MEETING DATE: February 22, 2021
FILE NO.: DR 20-0009
PROJECT: THE BEAN BARN

APPLICANT: Angela Copeland, Applicant

DR20-0009 Exhibit H: Exterior Elevations and Interior Floor Plan

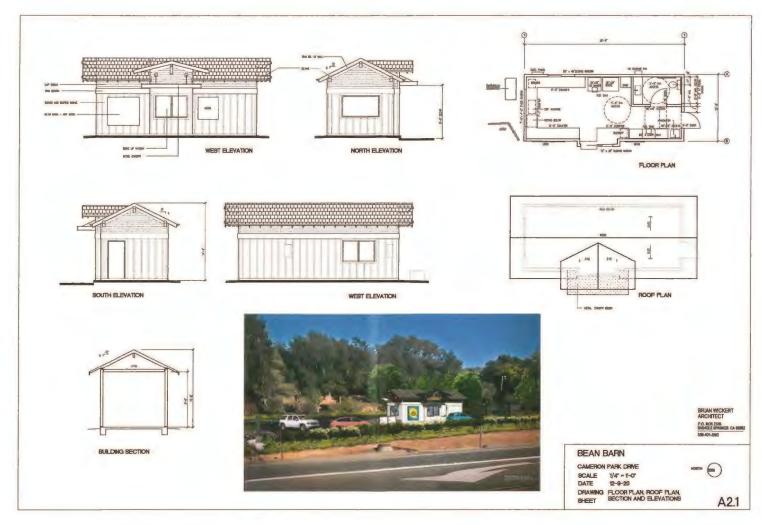
DESIGN REVIEW COMMITTEE COMMENTS		
X Cameron Park	Pollock Pines	Staff Review
Major Issue: The primary structure is relatively small, and there is another structure (storage) indicated on the site. Both structures should be of similar design, with earth-tone colors and brick or other natural materials used around the base of the buildings, as a wainscot, to be more in keeping with a rural setting and nearby commercial structures. Recommendation: Combine shed and trash enclosure to reduce a "disjointed" appearance of the project. Another option may be considered by re-siting the trash enclosure.		
Setbacks: Landscaping along property l	ines must be at least 10' in dept	h.
Landscaping and Existing Gr	owth:	
vehicular access ways. Lands along Cameron Park Drive to	caping, such as shrubs that grove	e not needed for structures, parking, and w to about 4 feet high, should be installed coffee. In addition, trees should be planted the interior of the project.

Vehicular Access:
No comment.
Ciding On Enterior
Siding Or Exterior:
Incorporate natural materials around base of structures. Board and batten and horizontal lap siding shown is acceptable. Applicant stated that the white color shown in the rendering is not accurate to the actual tan color proposed.
Colors:
Colors.
Incorporate earth-tone colors into the color palette. No color palette was presented. Recommend requesting color palette for CPDRC review.
Roofing Materials:
Rooting Matchais.
Consider using standing seam metal roofing to complement the proposed design.
Air Conditioning:
Screen ground mounted equipment with landscaping.
Roof-Mounted Items:

Given the proposed design and small stature of the building, roof mounted items shall be discouraged. Any roof-mounted items shall not be visible from the adjacent streets.
